Re: Minor Project Refinement No. 10 for the South Orange County Reliability Enhancement Project.

South Orange County Reliability Enhancement Project CPUC Minor Project Refinement Form

Report No.: 10

ATTACHMENT B
MPR-10 Figure

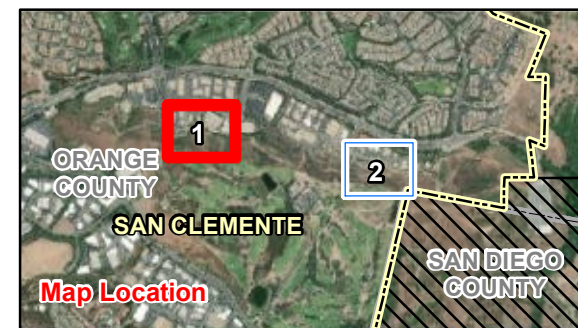
Access road improvements at Location 1 between Pico Substation and transmission pole #38 will include mowing vegetation for fire mitigation, and minor grading of the berm. Access road improvements at Location 2 at the access road entrance off of Calle Avanzado, north of transmission pole #41, will include replacement of the existing bridge with a wider, temporary bridge and earthwork (grading and adding fill material) to increase the width of the access road to approximately 14 feet wide and create an approximate 2:1 slope. SDG&E has rights to make

The access road improvements are required for larger equipment to maneuver along the roads, for example during transportation of new poles, steel beams, and retaining wall materials (See **Attachment B, MPR-10 Figure**). These two locations are critical for transmission line construction as there are very few access road entrances that lead to work areas in the Talega Hub and Corridor. All other viable access points would also require road improvements for larger equipment, and the MPR-10 areas were determined to be the least impactful options.

Maps & Figures: Refer to **Attachment B, MPR-10 Figure**, for a map of the proposed MPR-10 temporary work area locations. Refer to **Attachment C, MPR-10 Site Photographs**, for pictures of the current conditions within the MPR-10 temporary work areas.

COA-1. The extent of the activities for MPR-10 (i.e., use of two temporary work areas for access road improvements near Pico Substation and transmission pole #41) will be limited to the approximate locations shown on the figure titled "SOCRE PROJECT, MPR-10 Figure 1".
